Our Ref: ST3118/2302-FRA Addendum

Harefield Grove, Harefield
Flood Risk Assessment Addendum

This Addendum has been prepared to provide further information in relation to the Greater London Authority (GLA) comments associated with the proposed development at Harefield Grove, Harefield (Planning Application Reference: 28301/APP/2022/2205).

A drawing has been prepared which identifies the existing surface water flood risk within the site, with the site specific topographical survey overlain. This drawing, ST-3118-503, is provided in **Appendix A**.

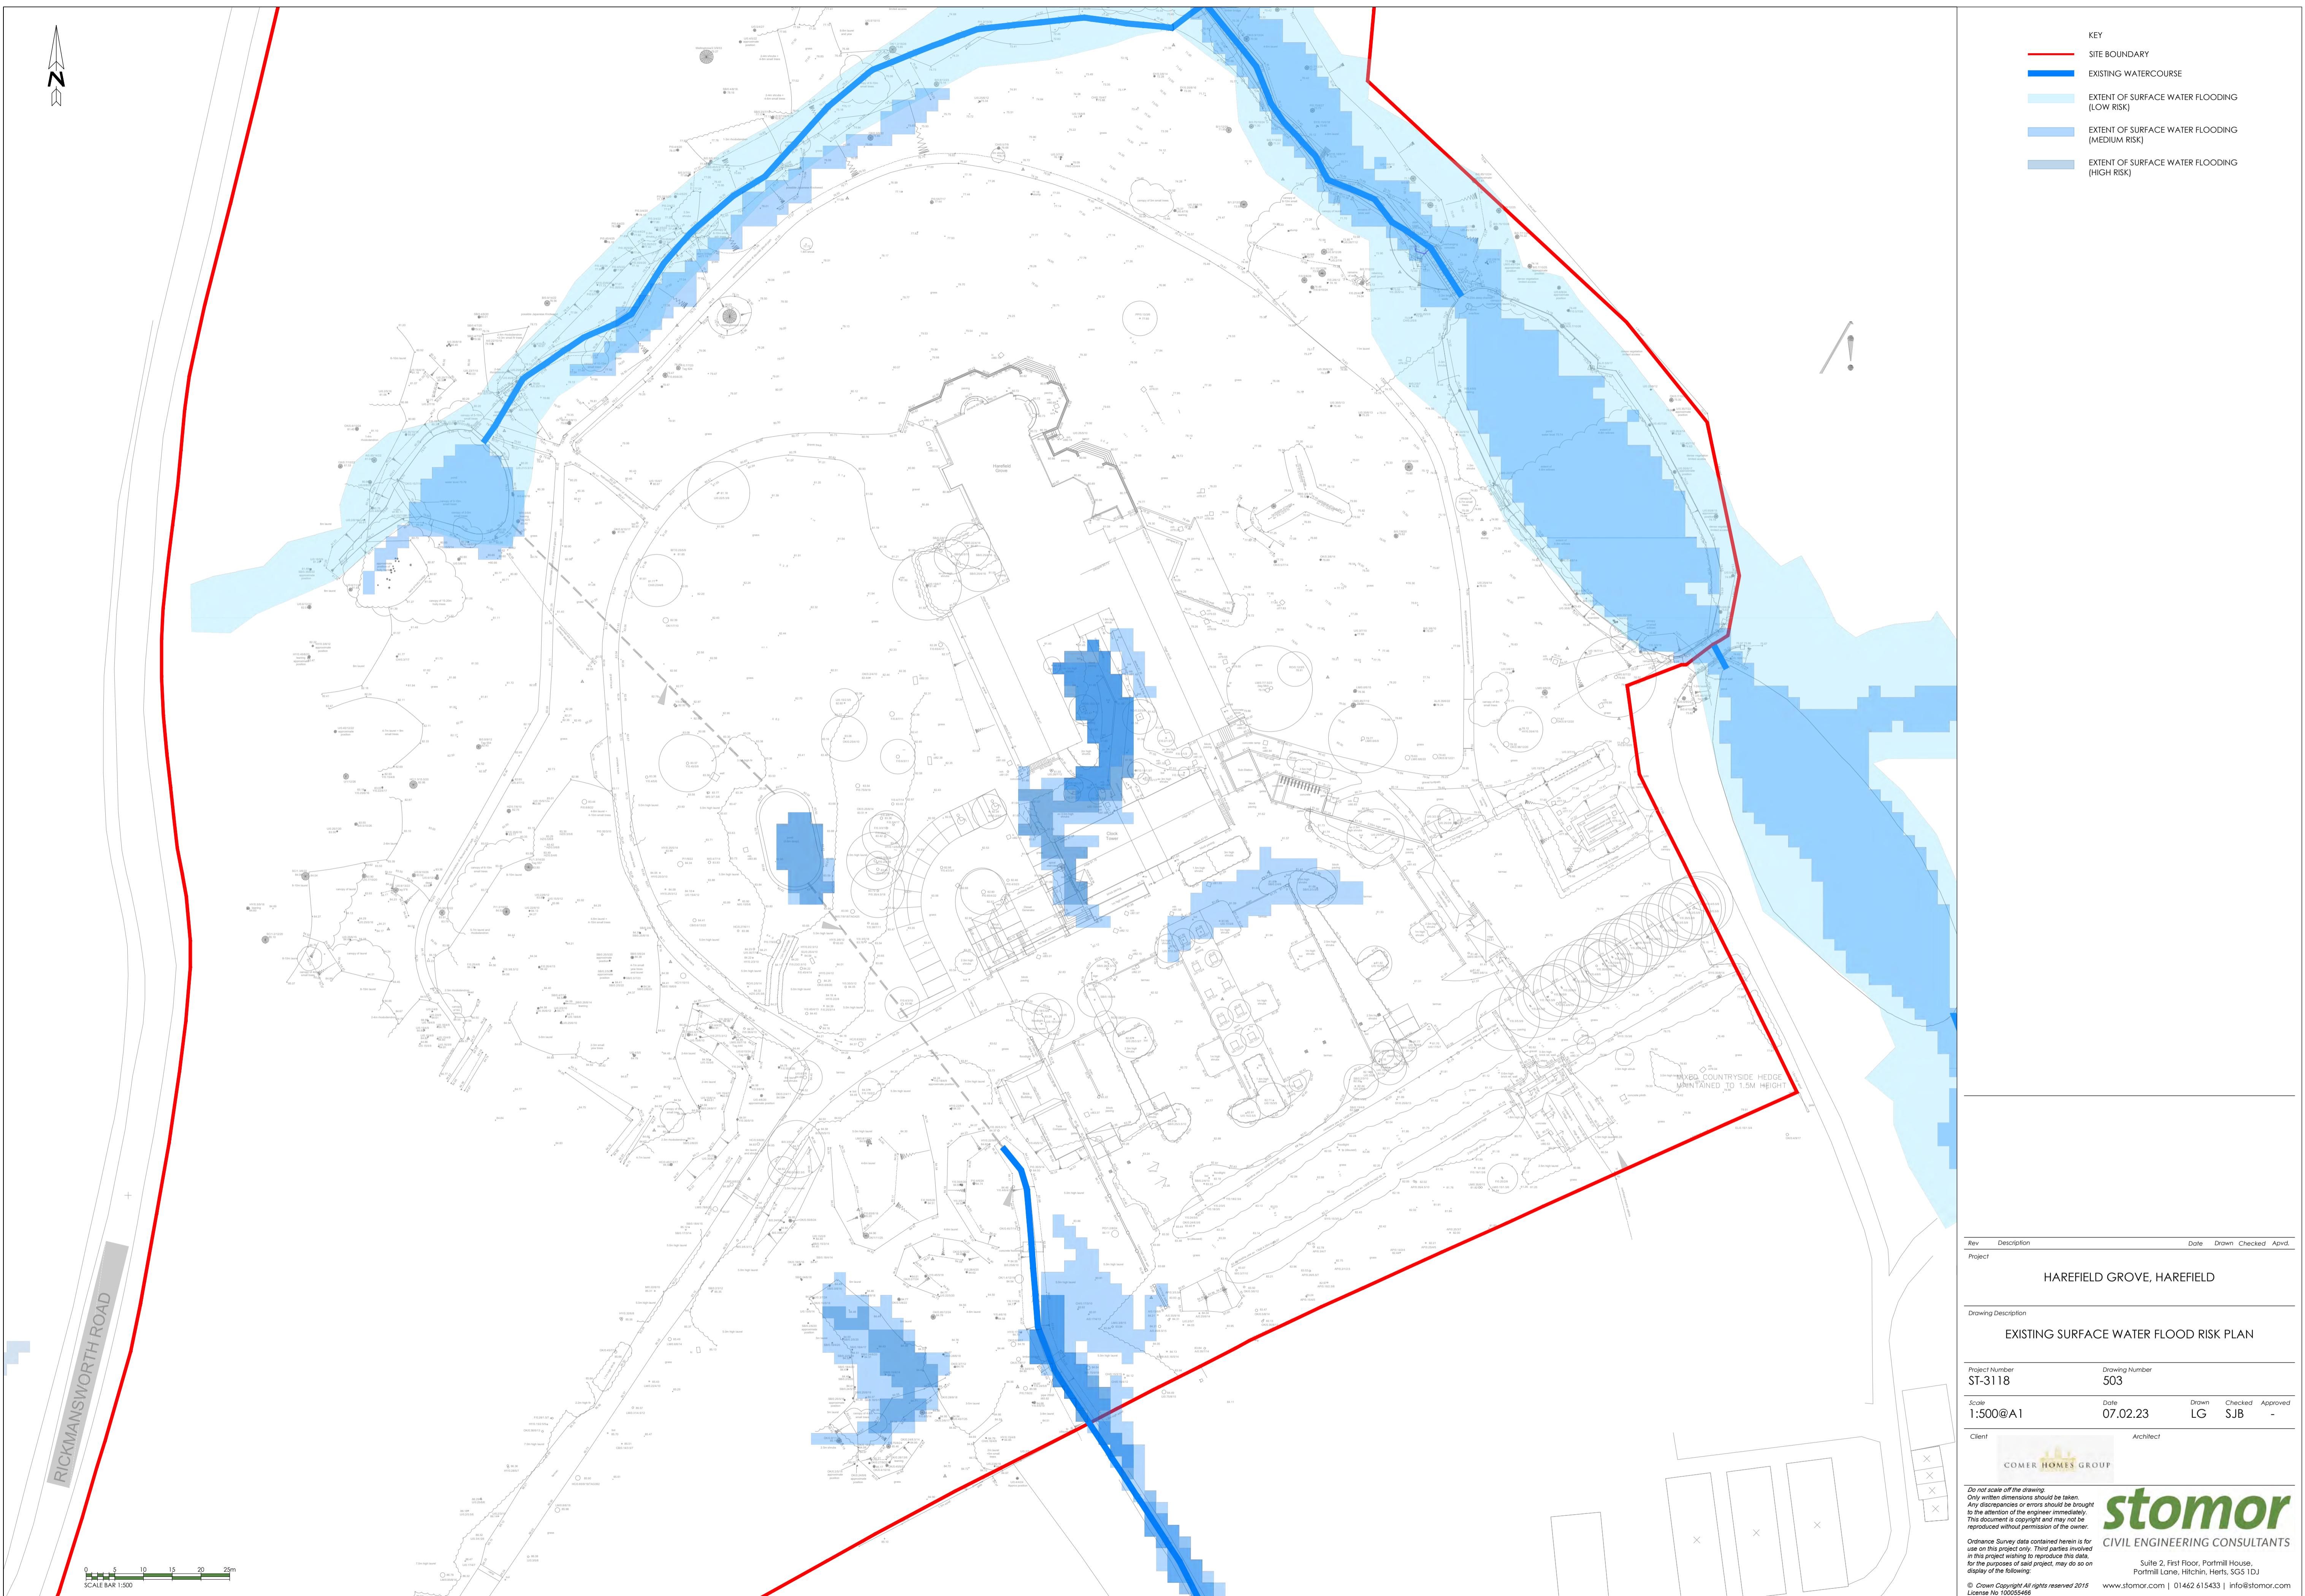
86. There are small sections of land around the existing manor house at medium/high risk of surface water flooding. The FRA states that 'overland flow paths will be taken into account in the design of levels for the proposed development to direct overland flows away from buildings'. This is supported but further information on the proposed levels and direction of flows needs to be provided, also to confirm that floodwater is not displaced off site as a result of the scheme.

The drawing shows that the existing surface water flood risk within the site is primarily confined to the areas within and in the vicinity of watercourses, ponds and water features. There is an area of medium to high risk of surface water flooding within the vicinity of the existing building. Inspection of the topographical survey indicates that this is a local low point, which accumulates within the southern side of the building. Overland flows do not have a route to pass the building due to its 'U-shaped' design.
